PBFM SUBDIVISION

APPLICATION NUMBER 2 DATE April 6, 2023
APPLICANT PBFM Subdivision
REQUEST Subdivision

DETAIL SITE PLAN

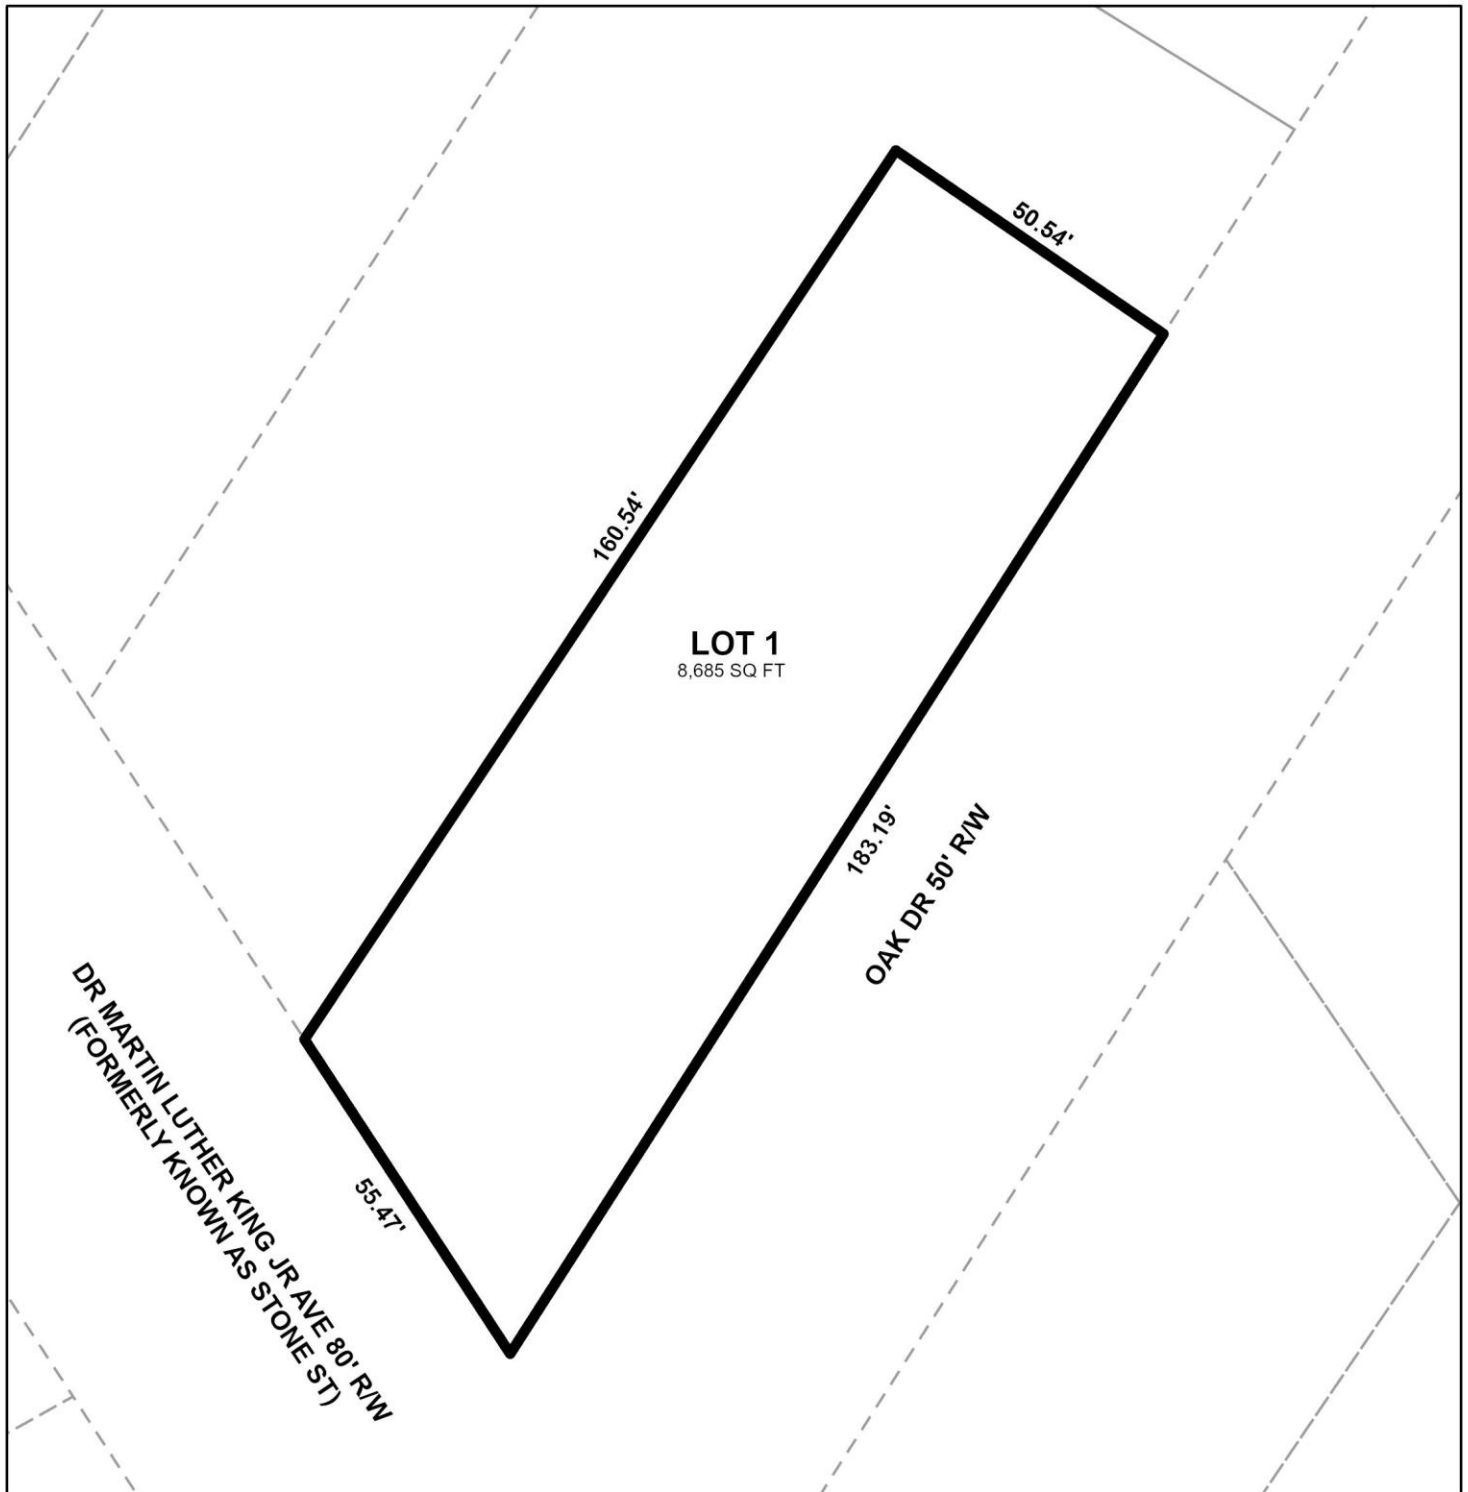
- B. Dedicate the corner radius (10' minimum or as approved by the City Engineer and Traffic Engineer) at the southeast corner of LOT "Parcel" and list the amount of dedicated acreage (sf and acre).

- C. Provide a designation for the proposed "Parcel" (i.e. LOT 1, LOT A).
- D. Delete NOTES #1-4 and #6. Those are standard notes for a PUD drawing not a PLAT.

It should be noted that the preliminary plat erroneously labels Oak Drive Court as simply Oak Drive. Therefore, the name should be corrected on the Final Plat, if approved.

The preliminary plat does not indicate the required street frontage setbacks. The plat should be revised to illustrate a 25-foot minimum building setback line along Dr. Martin Luther King, Jr. Avenue, and a 20-foot minimum building setback line along Oak Drive Court. The proposed lot meets the minimum size requirements of the Subdivision Regulations. As on the preliminary plat, the lot size label in both square feet and acres should be retained on the Final Plat, revised for any required dedication, or a table should be furnished on the Final Plat providing the same information.

- 1) revision of the street name label for Oak Drive to correctly read Oak Court Drive on the Final Plat;
- 2) retention of the right-of-way widths of Dr. Martin Luther King, Jr. Avenue and Oak Court Drive on the Final Plat;

- 3) dedication to provide a 25-foot corner radius at the intersection of Dr. Martin Luther King, Jr. Avenue and Oak Drive Court;
- 4) revision of the plat to illustrate the 25-foot minimum building setback line along Dr. Martin Luther King, Jr. Avenue on the Final Plat;

- 5) revision of the plat to illustrate the 20-foot minimum building setback line along Oak Drive Court on the Final Plat;
- 6) retention of the lot size label in both square feet and acres on the Final Plat, revised for any required dedication, or the furnishing of a table on the Final Plat providing the same information;
